AGENDA
CITY OF LAKE WORTH BEACH
HISTORIC RESOURCES PRESERVATION BOARD REGULAR MEETING
BY TELECONFERENCE
WEDNESDAY, AUGUST 12, 2020 -- 6:00 PM

RE: **717 Lake Avenue**

RE: **221 Princeton Drive**

1950 Architectural Drawing, Front Facade

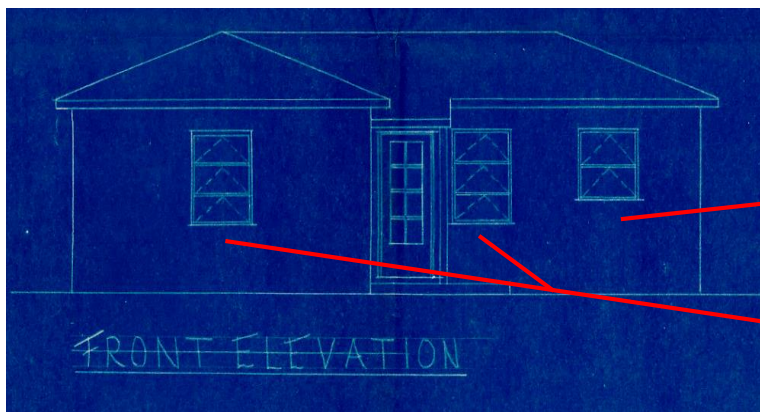
The proposed project, subject to the conditions of approval that require aluminum-framed windows that replicate the existing 2-light and 3-light awning windows, is consistent with Goal 1.4 of the Comprehensive Plan, which encourages preservation and rehabilitation of historic resources. Policy 3.4.2.1 insists that properties of special value for historic, architectural, cultural, or aesthetic reasons be restored and preserved through the enforcement of the City’s Historic Preservation Ordinance to the extent feasible. Per the City’s Historic Preservation Ordinance (LDR Sec. 23.5-4), the Lake Worth Beach Historic Preservation Design Guidelines, and the Secretary of Interior Standards for Rehabilitation, the replacement of missing features should be substantiated by documentary, physical, or pictorial evidence. The original architectural drawings and current photographs below provides evidence of the structure’s original/existing window configuration on the front façade.

As is typical with awning windows on Masonry Vernacular structures, all lights are equally sized depending on the height of the window opening.

North Elevation (Fronting Princeton Drive)

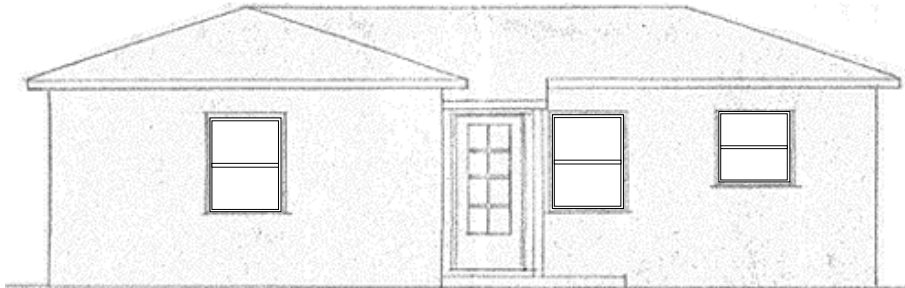
Install three (3) new vinyl impact single-hung windows without divided-light patterns.

- Window Frame: Vinyl
- Window Frame Finish: White
- Muntin Type: None
- Glass Type: Clear or Clear Low-E

Install two (2) aluminum impact casement windows (Alternates: fixed, awning, or hopper) with divided-light patterns to replicate the 3-light awning windows. Install one (1) aluminum impact full-view single-hung window (Alternates: casement, fixed, awning, or hopper with divided-light patterns) to replicate the 2-light awning windows).

- Window Frame: Aluminum
- Window Frame Finish: Clear-Anodized
- Muntin Type: Exterior Raised Triangular
- Glass Type: Clear or Clear Low-E

Staff Recommendation (Most Successful Replacement)

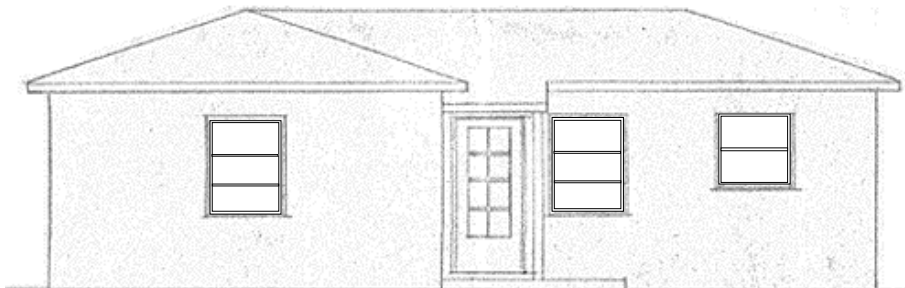
The Staff recommended partial window replacement for the front façade could be approved administratively at permitting. The partial window replacement, as proposed, could not be approved administratively as the window types, frame material, and lack of divided light patterns are a change in design from the original window configuration. The original/existing 3-light awning windows are being replaced with full-view single-hung windows with white frames. The original/existing 2-light awning window is also being replaced with a full-view single-hung window with white frames.

The Applicant is also proposing to install windows with vinyl frames. When replicating metal awning windows, Staff always recommends that the replacement windows utilize aluminum window frames as they are the most historically compatible frame options for material, design, color options, and overall proportion. In addition, aluminum-framed windows are commonly utilized due to their wide availability, versatility, and affordability.

The window replacement, as proposed, utilizes single-hung windows on all of the front façade's openings. Based on the Design Guidelines, an Applicant may propose an architecturally compatible alternative for window replacement. The Masonry Vernacular architectural style section of the Design Guidelines, included as **Attachment E**, provides examples of common window types. Staff contends that the proposal is *unsuccessful* in replicating the original windows. Per the Design Guidelines (pg.61), hung windows are only appropriate on Masonry Vernacular structures constructed before 1930. Post 1930, Masonry Vernacular windows consisted of "either steel casements, or aluminum awning, jalousie, or fixed pane windows". Architecturally compatible alternatives are appropriate when none of the original windows remain and there is no architectural or photographic evidence of their design. The structure's original windows remain and can be readily replicated with modern window products. Additionally, it is not possible to add exterior muntins to the proposed windows to arrive at a similar divided light configuration where the lights are equally sized for both window sizes.
